# TECHNICAL INFORMATION

75361  
January 2006

**Subject** ▶ Change of Gear Ass'y

**For Models** ▶ 6319D, 6339D, 6349D, 8414D, 8434D, 8444D, BDF441, BDF451, BHP441, BHP451

**Fig.1.**

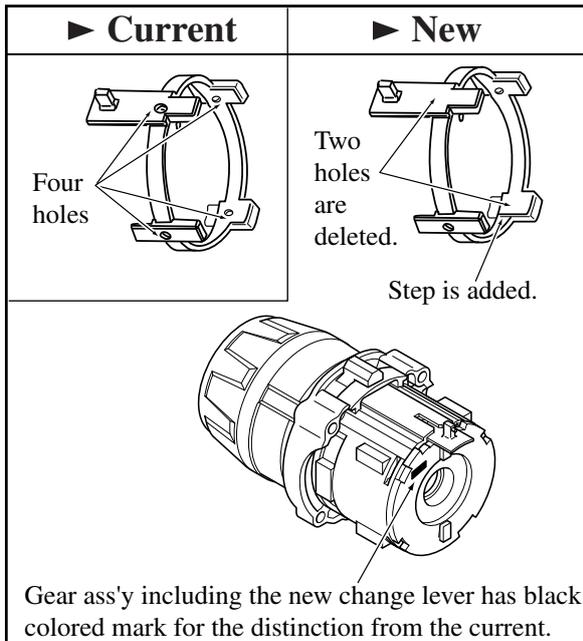
**Description** ▶ The shape of change lever (the component of Gear ass'y) has been modified as shown in **Fig.1**. Gear ass'y has been changed because of the modification for the shape of gear case A (the component of Gear Ass'y). As illustrated in **Fig.2**, the color of lot No. has been changed for the distinction. As illustrated in **Fig.3**, Speed change ring has also been changed.

Fig.1: From January 2006 production
